City of Portland Historic Landmarks Commission

Design Advice Request

Date: November 21, 2022
To: Jeff Hawthorne, City of Portland, OMF
From: Hillary Adam, Design & Historic Review Team
503-823-8953 | hillary.adam@portlandoregon.gov
Re: EA 22-188130 DAR – Thompson Elk Fountain
Design Advice Request Commission Summary Memo – November 7, 2022

RE: Early Assistance Application: Design Advice Request for restoring the Thompson Elk Fountain, a Historical Landmark

Plan & Section
Schematic Installation Plan

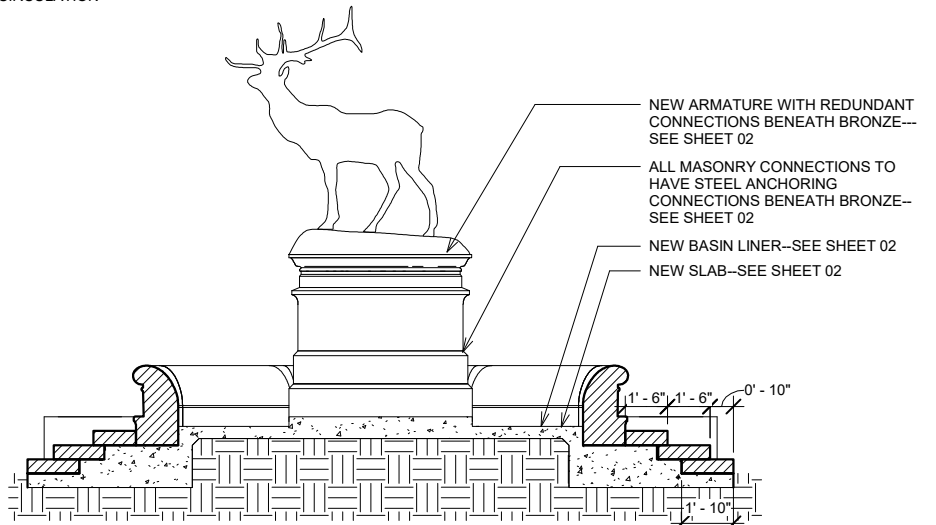
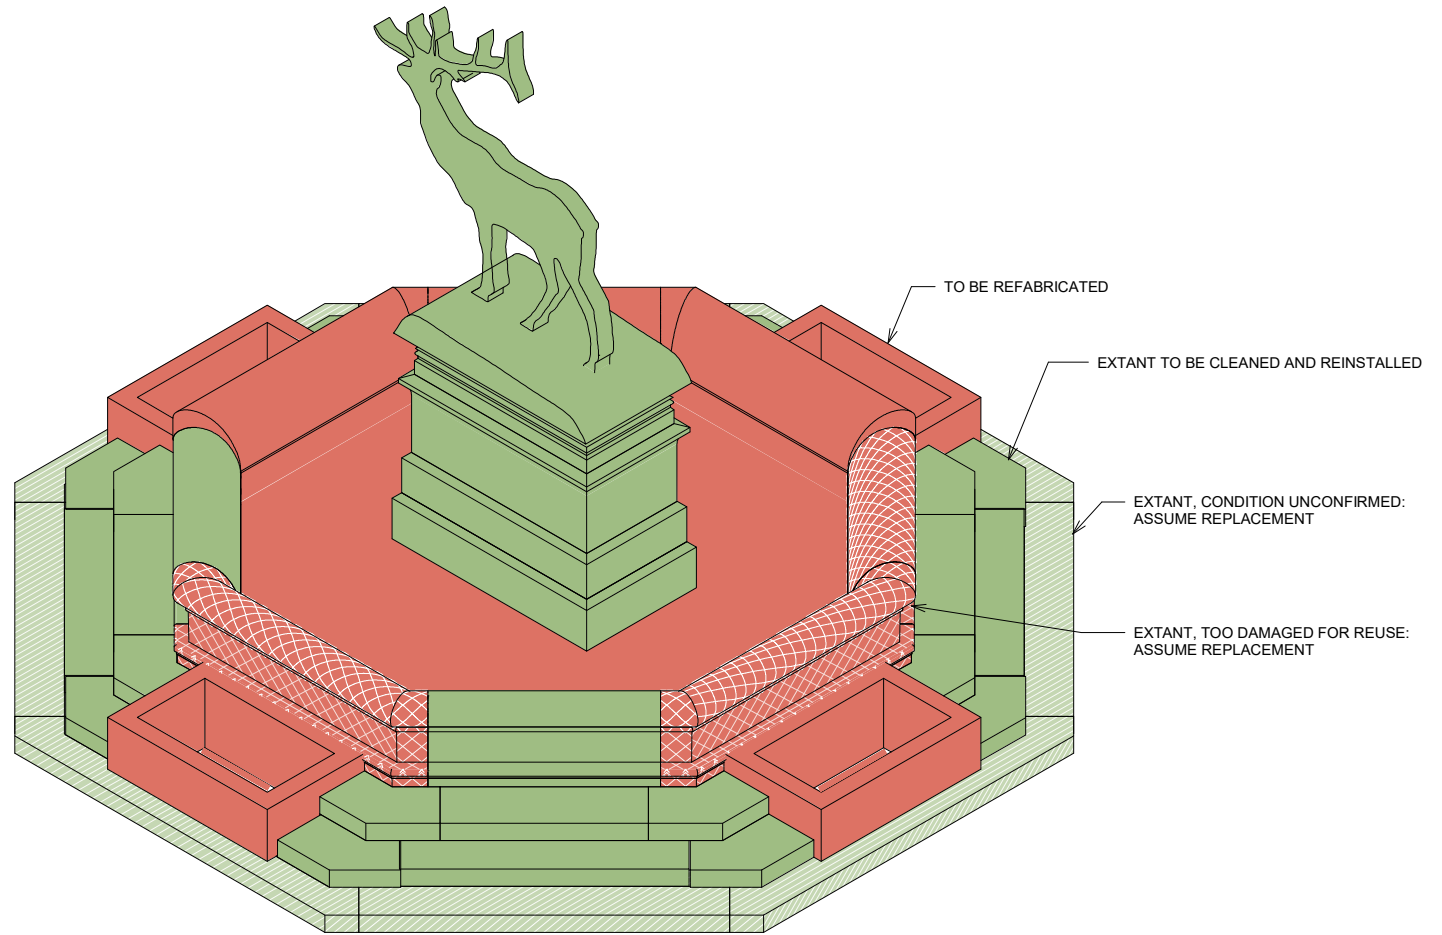
It is staff's understanding that the fountain and elk statue have historically been held in place by gravity only. It would be highly preferable to have seismic stabilization of the fountain and statue so the historic resource does not move or topple into traffic during a seismic event. It is likely possible to do this stabilization without impacting the exterior of the fountain.

The proposal appears to also include a new vault for a pump associated with the fountain within the roadway. This vault will need approval from PBOT Utilities.

2. **Recirculating Pump.** As was required by the City Council resolution, the restored fountain will feature recirculating water in order to minimize its water consumption. The plan shows that the new pump will be located in a below grade vault on the west side of the fountain, thus minimizing its impact on the visual experience of the fountain to most viewers.
